Update of changes to CNGS layout and parameters

The CNGS project team

Abstract

Fig. 1: New layout showing the access path from TI 8 to TNM41 and TNM42.

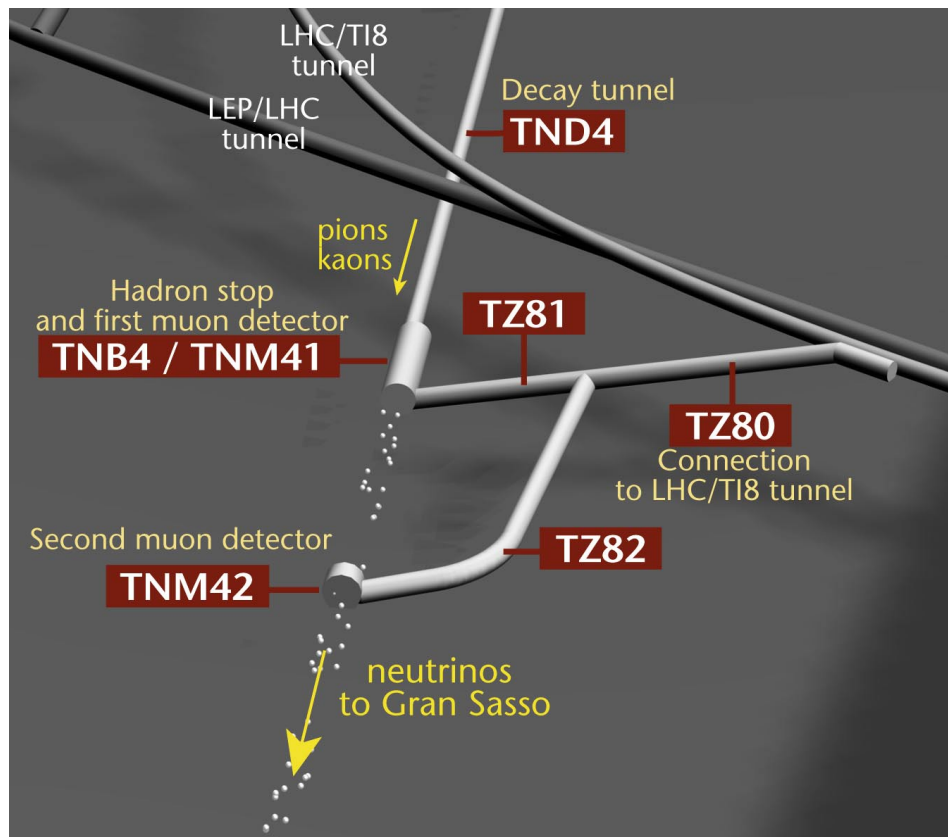
After examining many different possibilities, the most attractive option found was to connect the hadron stop and muon detector chambers, TNB4, TNM41 and TNM42, to the LHC injection tunnel TI 8. The new access tunnels are called TZ80 (for the connection from TI 8 to the junction for the second muon detector chamber), TZ81 and TZ80 (for the parts connecting TZ80 to TNM41 and TNM42) – see Figure 1.

Fig. 2: Layout of the upstream part of CNGS, showing the additional gallery TAG42.

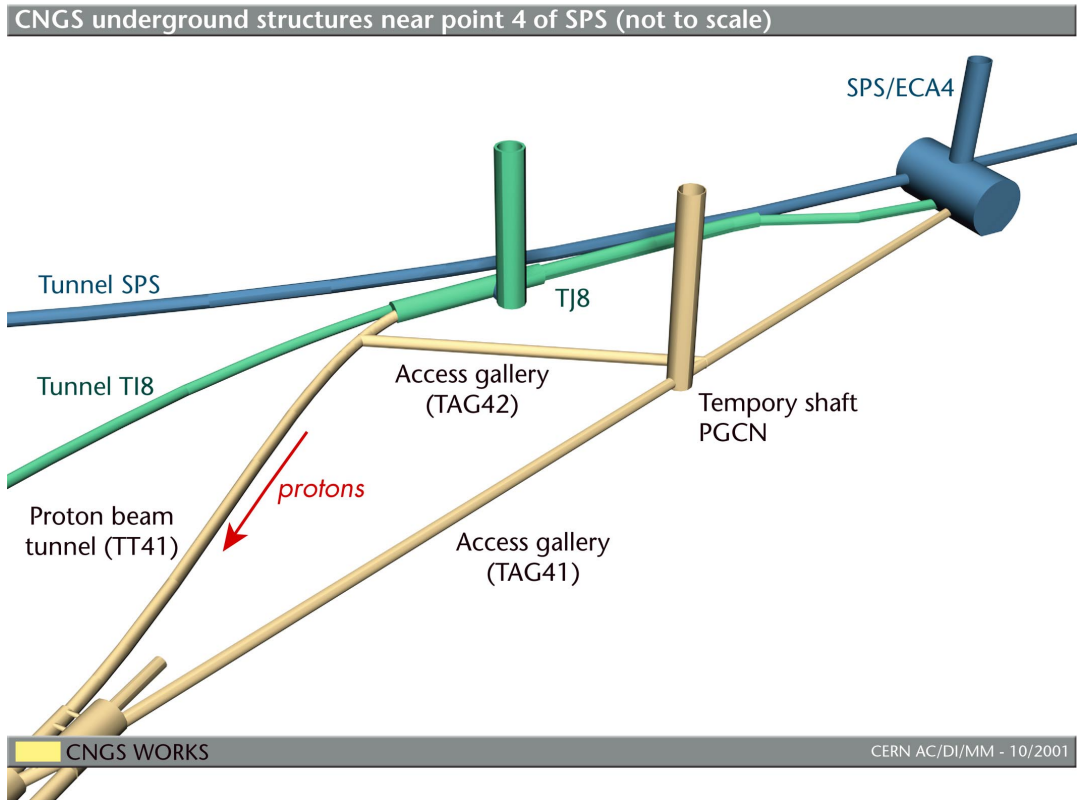
Soon after the start of civil engineering works, the underground civil engineering contractor approached CERN with a proposal to build an additional gallery, from a point in the main access gallery (TAG41) just upstream of the civil engineering shaft to the TT41 proton beam tunnel (see Fig. 2). The main motivation for the proposal was the possibility to advance excavation on two fronts, i.e. with the Tunnel Boring Machine via TAG41 to TCC4 and into the decay tunnel TND4, and with a road header via TAG42 into TT41. The contractor forwarded an interesting proposal for sharing the cost and risks for the construction of this new gallery, and this proposal was finally accepted by CERN. According to the modified contract, the final cost to CERN for this gallery is linked to the completion date of the civil engineering works (no cost to CERN if the underground construction finishes late) – so until construction work is finished, any extra cost cannot be assessed.

Fig. 3: Enlarged section of the junction gallery between TCV4 and TCC4.

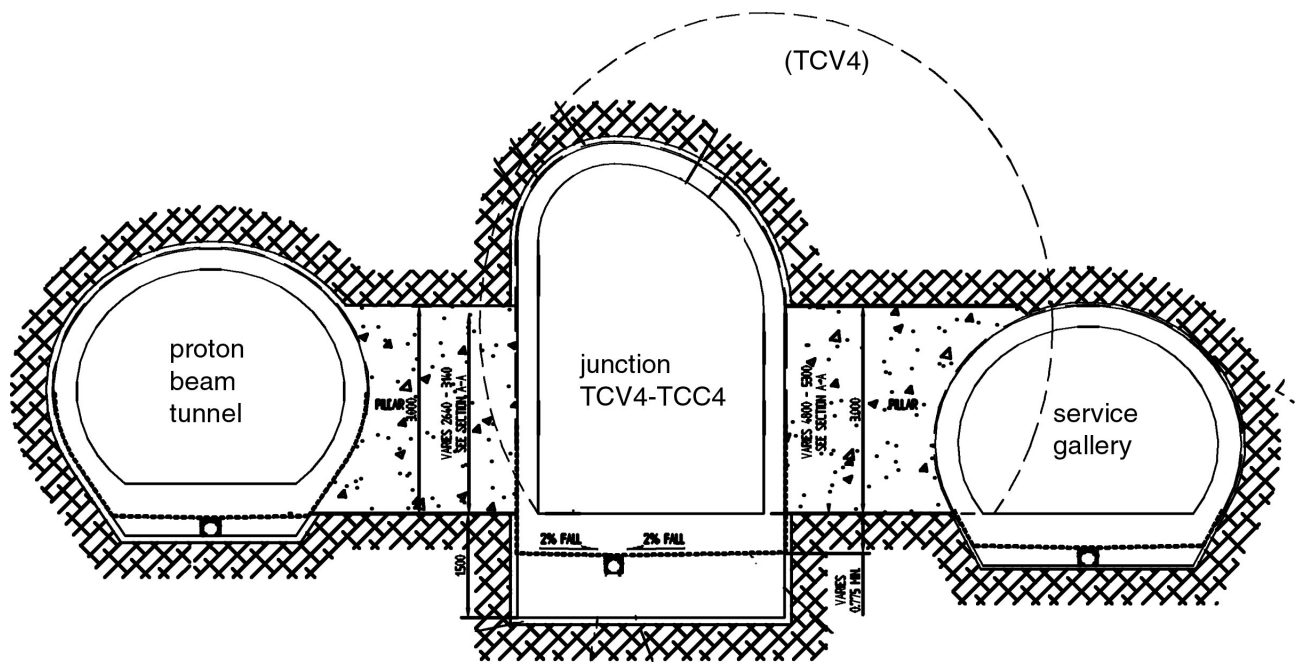
This solution implied a modification to the civil engineering layout, in particular an enlargement of the connecting gallery between TCC4 and TCV4. An Engineering Change Request for this modification was approved by the Technical Working Group.

Fig. 4: Schematic cross section of the hadron stop cavern, showing the beam dump with its graphite core, the top and bottom cooling plates, surrounded by iron blocks. No concrete filling around the iron is foreseen.

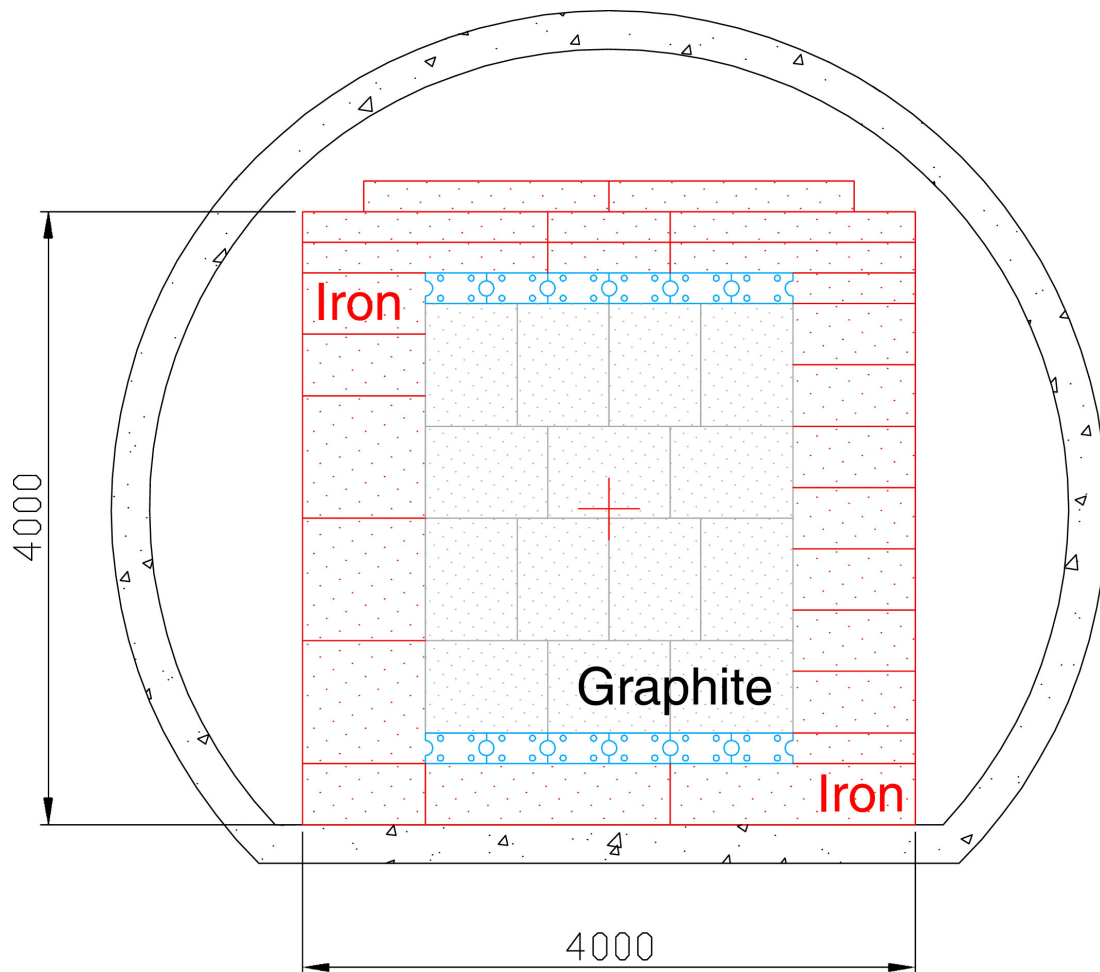
The evolution of neutrino physics, together with the excessive cost for a detector cavern at the ‘near’ location, had as a result that the ideas for such ‘short-baseline’ experiments were not pursued. This allows us, in the present version of CNGS, not to fill the voids around the dump in TNB4 with concrete. An additional benefit of this solution would become apparent should the dismantling of the hadron-stop sometime after the end of CNGS operation be required. A section across the hadron-stop in TNB4 is shown in Figure 4.

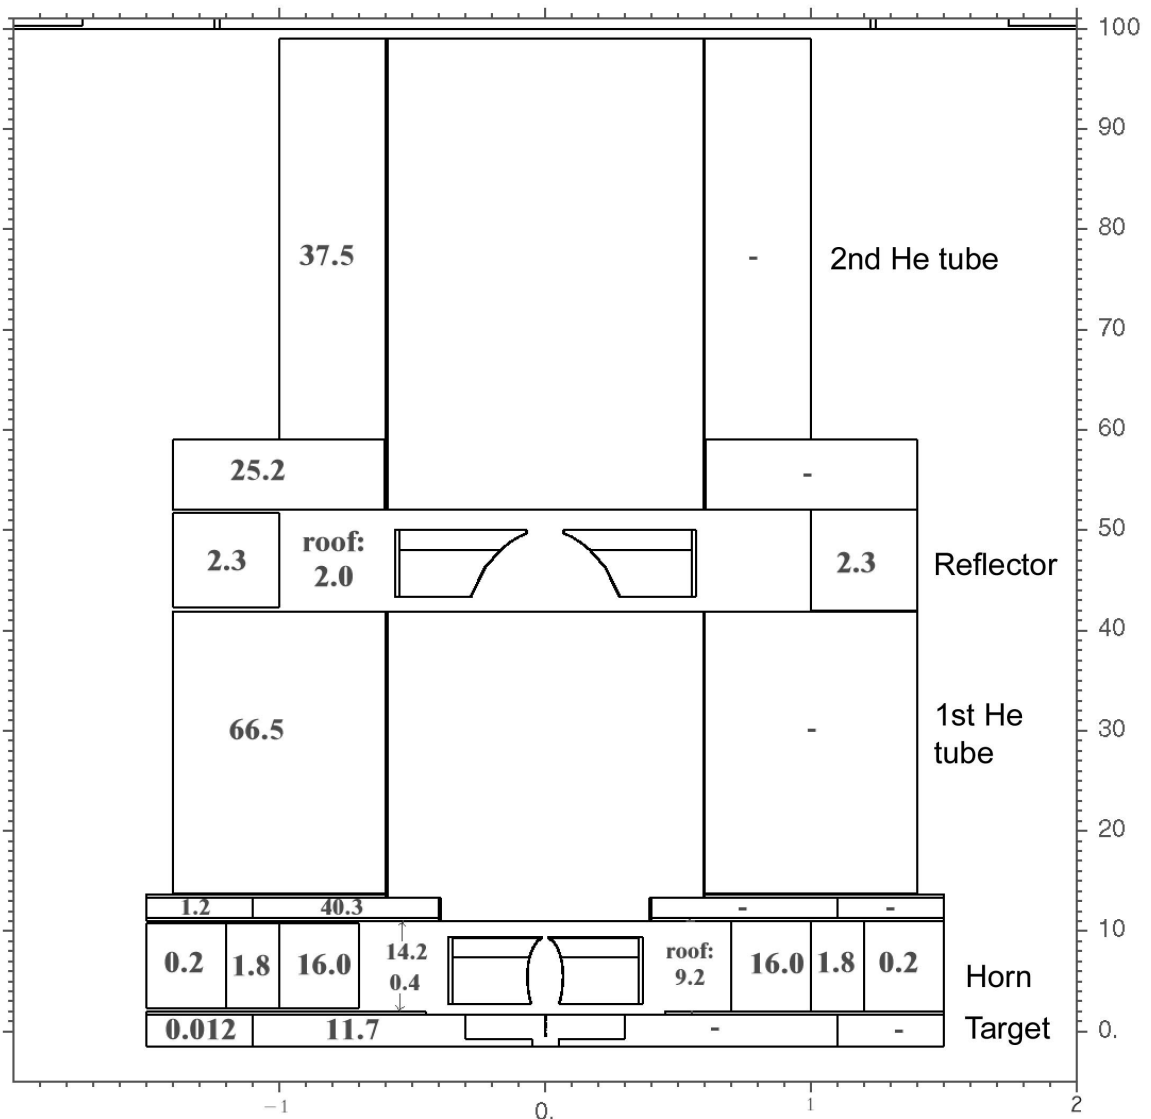
The heat deposited in the structures of the TCC4 target cavern is such, however, that the cooling power from the ventilation system foreseen for this area could not cope - see Figure 5. In anticipation of higher proton beam intensities, it was therefore decided to provide the possibility for additional cooling. The solution adopted is to reserve space for five air-conditioning units in the service gallery TSG4 (50 kW cooling power per unit), and to drill two holes (in addition to the passages TSG41...TSG47, of which some might be used in the future for the same purpose) from TCC4 to TSG4. Ducts in TCC4 will distribute the cold air along the floor, and the hot air will be sucked in from the ceiling. The air-conditioning units contain a fan and a cooling coil connected to a chilled water circuit. The details of this system are still under study, but the size (1.10 metre diameter) and the location of the two additional holes has been decided (one near the target station, one near the upstream end of the reflector).

Fig. 6: The location of the annex to the BB4 building, here labelled “Annexe CNGS”.

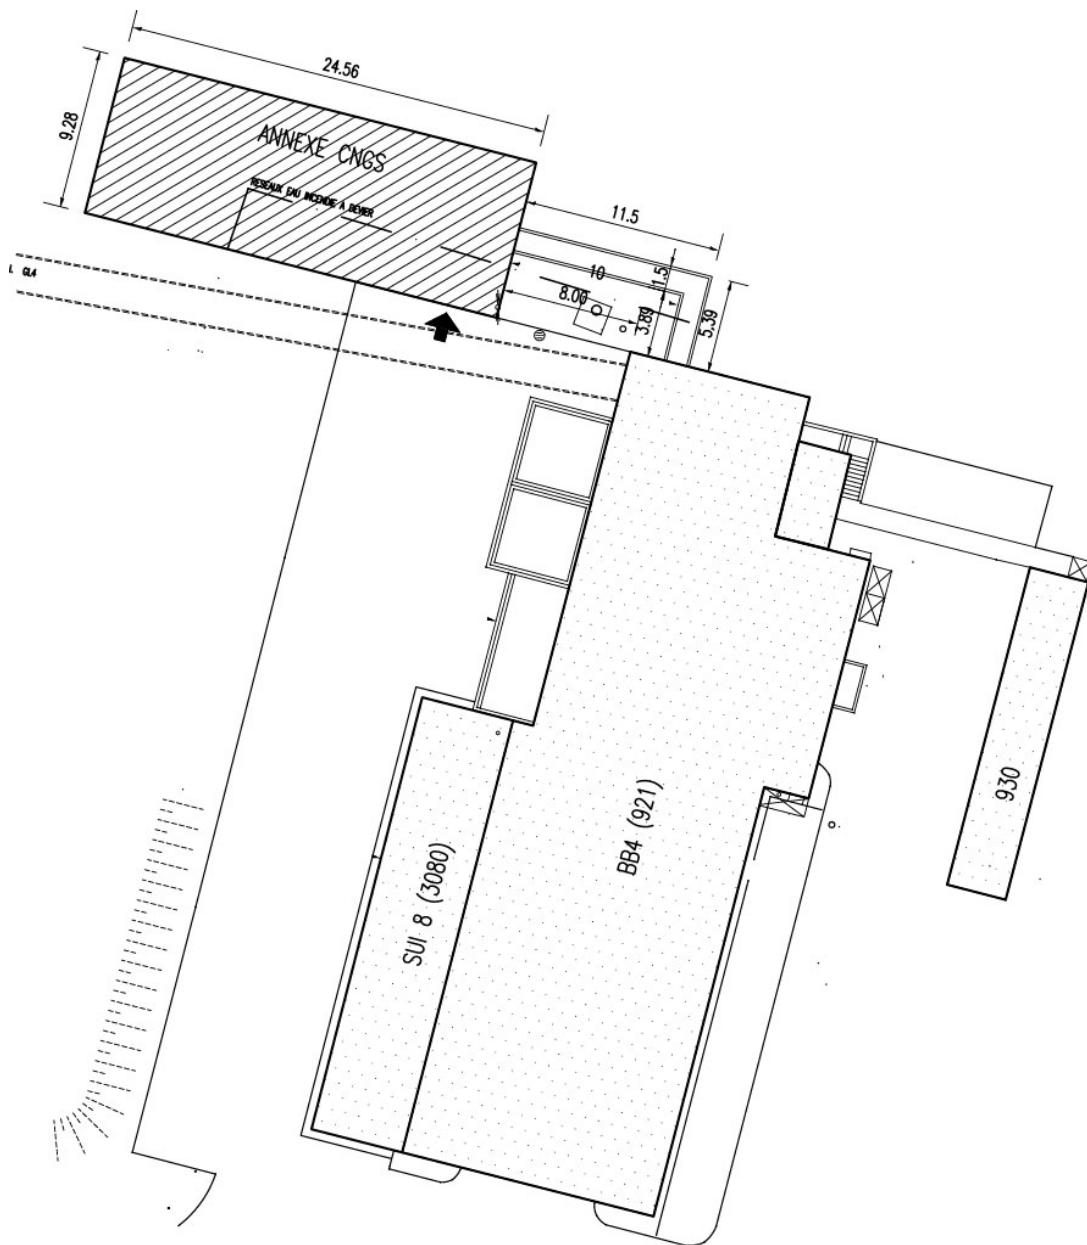
Point 4 of the SPS has become the focus of much installation activity for the new East extraction system, the TI 8 transfer line and the CNGS project. While it was felt initially that space would be available for all the equipment in the existing structures, it soon became evident that space and safety constraints made it necessary to build an additional light structure, now called the BB4 annex (see Figure 6 for the location of this annex).

Fig. 7: Layout of the powering equipment inside the proposed BB4 annex building.

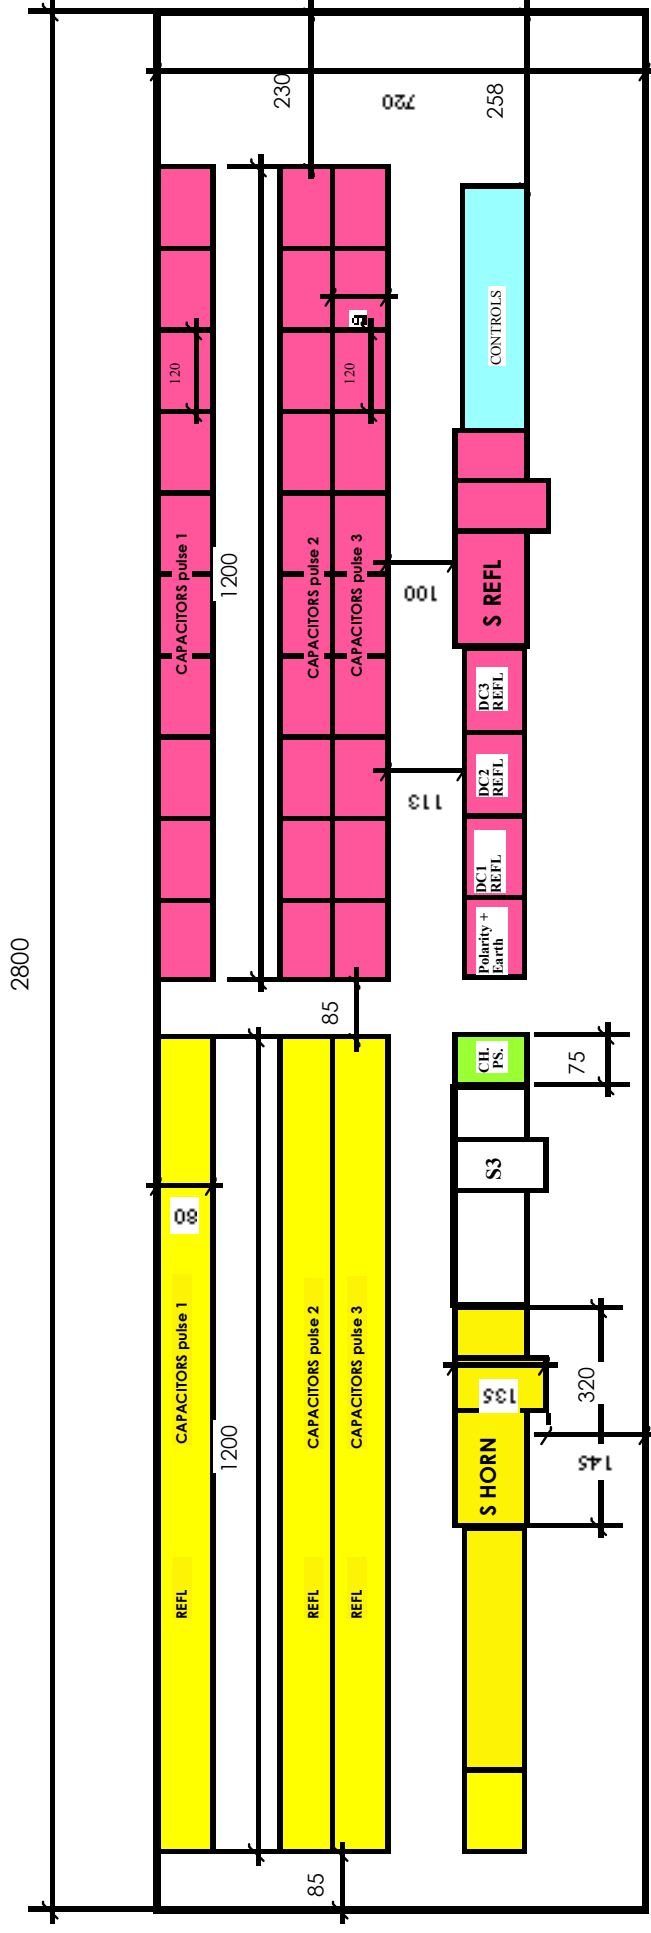
A working group has studied the possibility of building an annex to BB4, at ground level but very near the CNGS access point at BB4. The technical details (power, ventilation, false floor, transport issues etc.) have been examined and solutions evaluated. The safety issues have been addressed (oil retention in each rack, smoke detection, fire alarm, protecting wall towards BB4). The findings of this group have been presented to the CNGS Technical Working Group. The technical justification for constructing this annex was demonstrated, and the Technical Working Group accepted the proposal. The layout of the powering equipment inside this new building is shown in Figure 7.

(Note added after the CNGS Review: It appears likely that, with new capacitors of a higher density, the space available in ECA4 will be sufficient. Since these capacitors do not contain oil, there is no particular safety hazard. In conclusion, the BB4 annex described above might finally not be needed).

Fig. 8: Vertical section of the shielding in the region around target and horn.

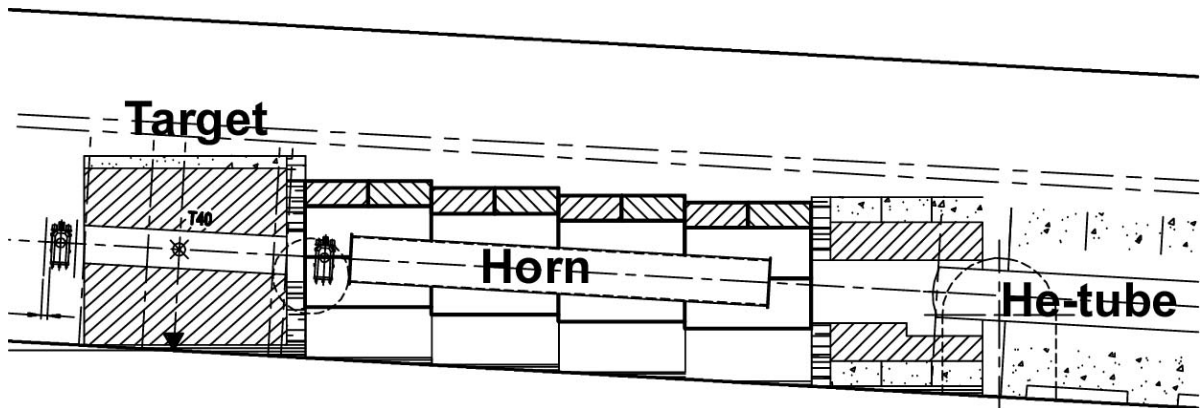
In the present layout of TCC4 [7], continuous shielding all around the target, horn, the reflector and both helium tubes is foreseen. A section of the layout is shown in Figure 8. (It was found that for the future increased proton intensities, the dose rate to the target chamber walls, including the crane rails etc., could become intolerably high if no roof shielding was foreseen along the secondary beam).
